### **Amendment to the Drawings**

The drawings have been objected to by the Examiner. Proposed drawing corrections are attached.

Docket No.: 10873.515US01  
Serial No.: 09/538877  
Sheet 7 of 8  
Reply to Office Action of Sept. 17 2004  
Replacement Sheet

**FIG. 1**

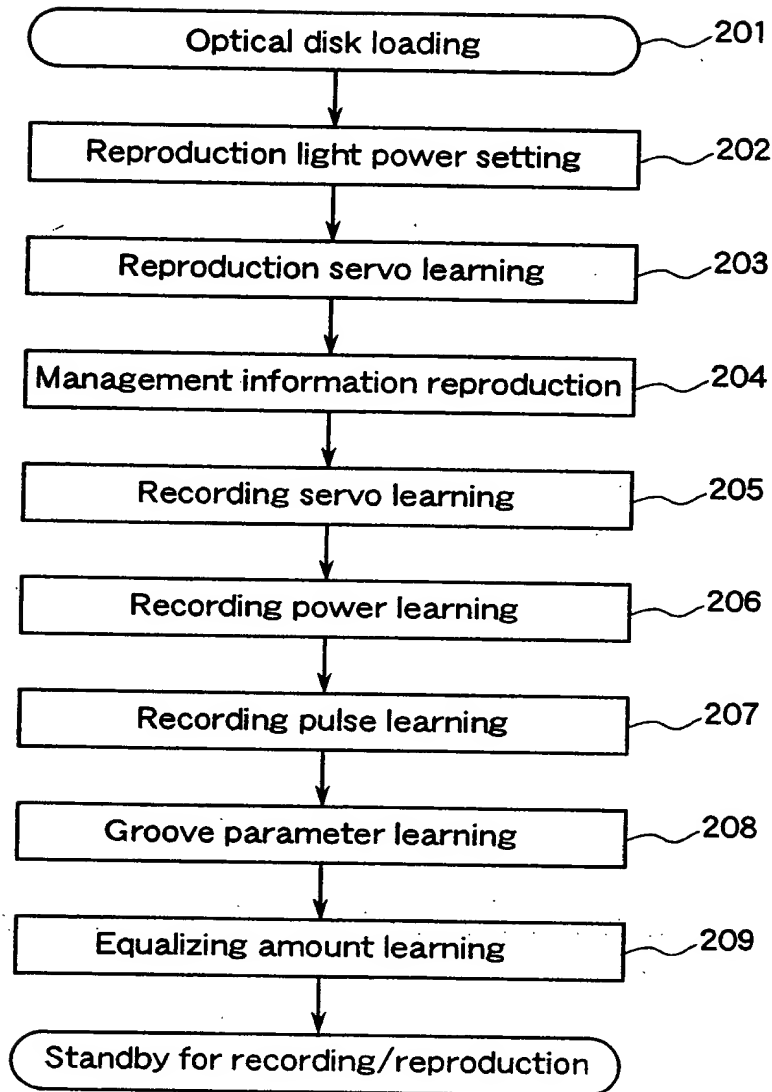
Figures 1 and 5 were amended by the previous amendment to label the circuit blocks. By this amendment, blocks 12, 17, and 23 are labeled as "case", "reproduction circuit", and "clamp", respectively.

FIG. 2

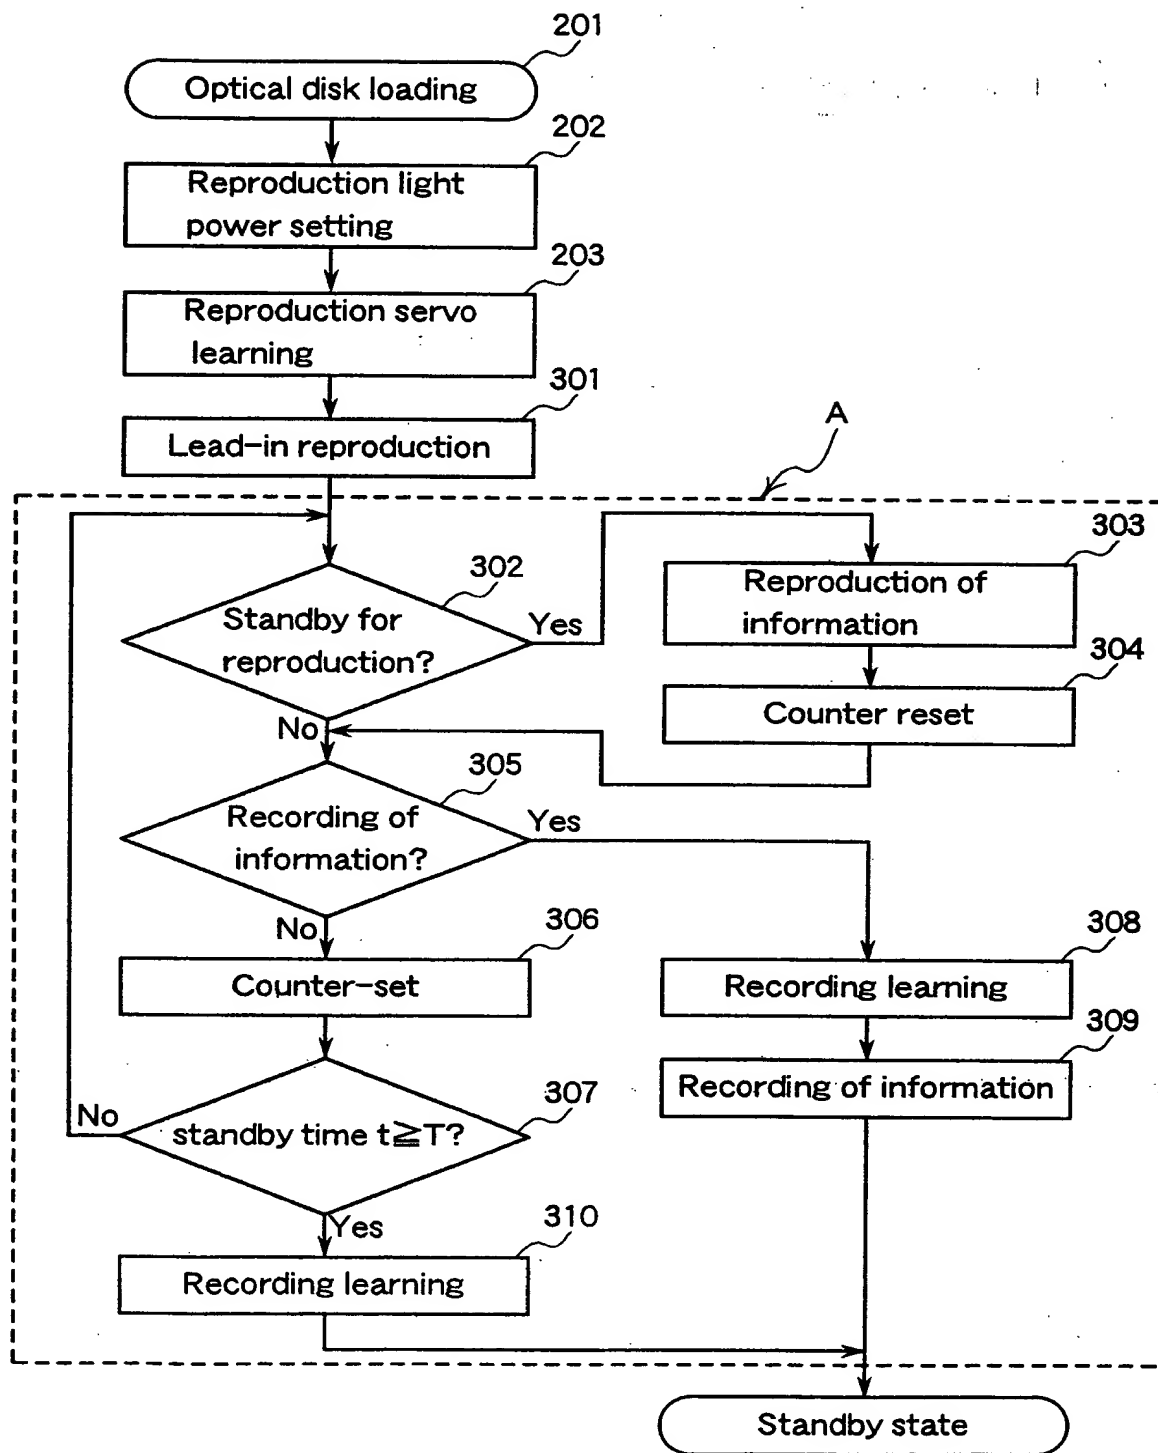
Figures 2-6 and 8 are amended to include English words.
